# DRAFT NATIONAL RADIO FREQUENCY PLAN 2017

(NRFP-17)

INDEPENDENT COMMUNICATIONS AUTHORITY OF  
SOUTH AFRICA

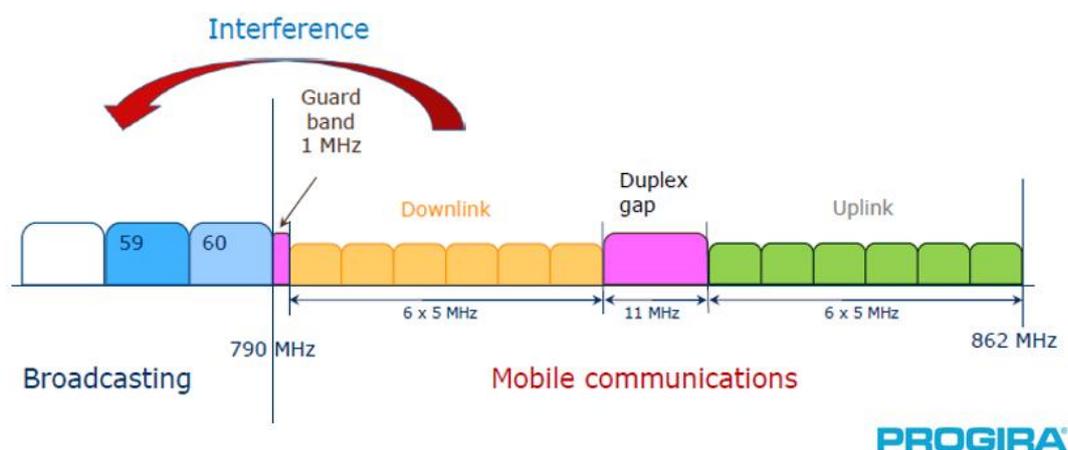
The deployment of IMT services and the adjacent channel co-existence of both services (DTT and IMT) should be in compliance with radio regulation footnote 5.317A:

The diagram below, illustrates the likely interference scenario that must be adequately managed in the event mobile services are deployed adjacent to broadcasting services in the same geographic area.

The co-primary allocation to broadcasting services in the bands 694 – 790 MHz and 790 – 862 MHz should not be removed. The introduction of mobile services can be co-ordinated. The broadcasting industry and mobile industry, under the leadership of the Authority should commence a workshop regarding coordination requirements and protocols with respect to the introduction of mobile services post-ASO.
